Rezoning Transportation Analysis

Petition Number: 2023-017

General Review Information

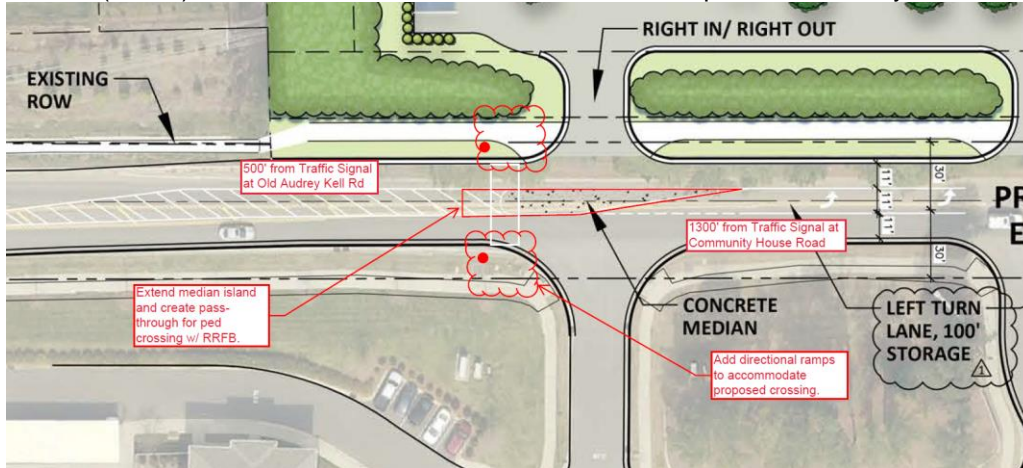
- 3. ~~Revise site plan to label and dimension the right of way. Provide sidewalk utility easement located at 2 feet behind the sidewalk if located outside of the ROW.~~**

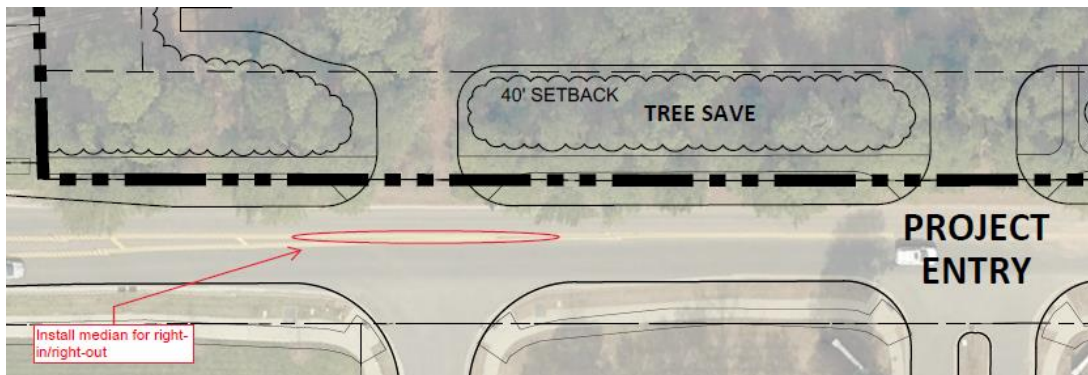
9. ~~Revise site plan and conditional note(s) to commit to making the western most access along Providence Road West right-in/right-out by installing a median that extends 25 feet before and 25 feet passed the site access. In addition a left turn lane should be provided at the main site access.~~

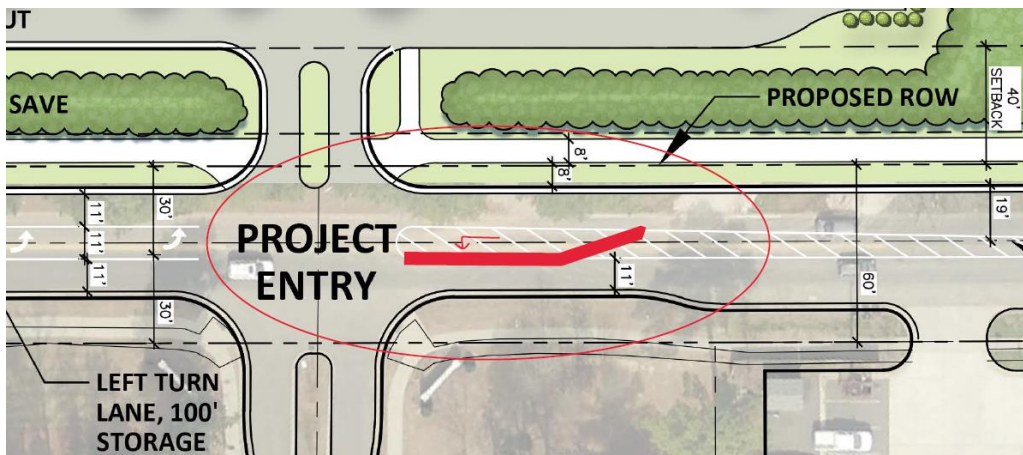
10. ~~CDOT REQUEST: Revise site plan and conditional note(s) to commit to installing sidewalk from the site to the intersection of Providence Road West and Community House Road to complete the pedestrian network.~~
